Request for Additional Information No. 392(4650), Supplement 2

U.S. EPR Standard Design Certification

SRP Section: 11.05 - Process and Effluent Radiological Monitoring

Question 11.05-21:**Phase 4 RAI****Follow-up to Open Item 276, Question 11-05-13, Supplement 2 Response**

Figure 11.05-21-1—Pre- and Post-Failure Total Airborne Particulate Concentration at the Radiation Monitor Sampling Location¹

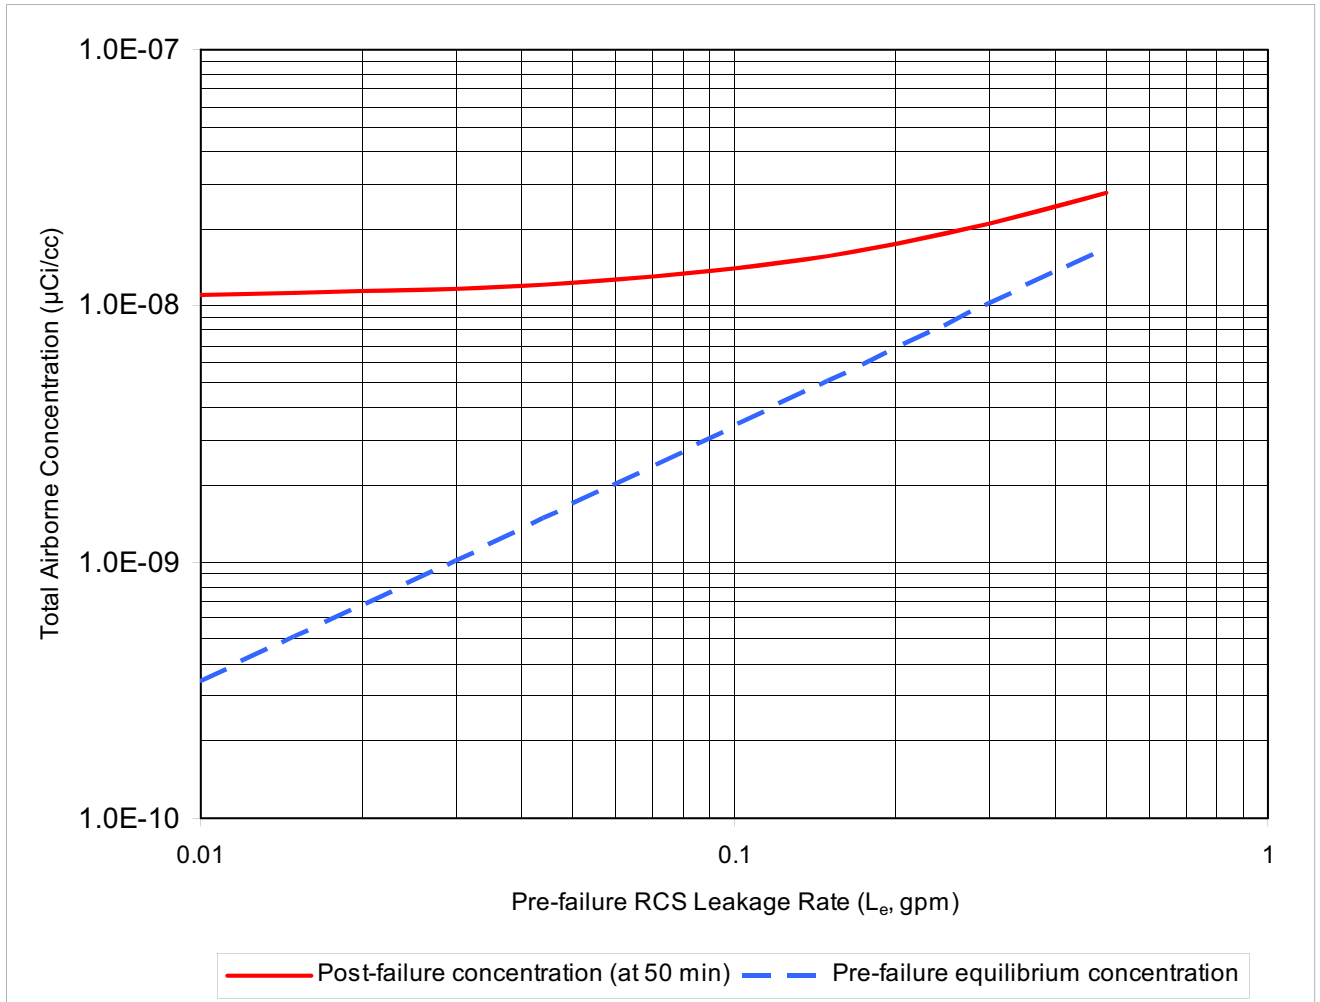
1. Figure 11.05-13-1 presented in the response should be expanded to include in the right ordinate axis, the derived dynamic response range of the instrumentation showing where the 1 GPM criterion would be met.

The Response to RAI 276, Question 11-05-13, Supplement 2 indicated that U.S. EPR FSAR Tier 2, Figure 11.05-13-1 would be revised to include, in the right ordinate axis, the derived dynamic response range of the instrumentation showing where the gpm criterion would be met. However, this is not feasible. The dynamic response of the monitor is relative to the pre-existing airborne activity and the associated background radiation level. The alarm setpoint will be established as a multiple of the background radiation (at least a factor of two). Therefore, the dynamic response is characterized as a multiple of the pre-existing activity. For example, if the pre-failure leakage rate is 0.1 gpm, which implies that the post-failure leakage rate would be $1 + 0.1 = 1.1$ gpm, the increase of airborne concentration within 50 minutes occurs by a factor of 4.14 (see Table 11.05-21-1).

A new figure (Figure 11.05-21-1) was developed to show the pre- and post-failure total airborne particulate concentration at the radiation monitor sampling location as a function of pre-failure reactor coolant system (RCS) leakage rate assuming a realistic reactor coolant activity concentration. The post-failure RCS leakage rate is 1 gpm higher than the pre-failure value. The ratio of these two plots is shown in U.S. EPR FSAR Tier 2, Figure 11.05-13-1 as a result of the response to RAI-276. This figure is also shown as Figure 11.05-21-2. Tabulation of the plotted results in these two figures is shown in Table 11.05-21-1.
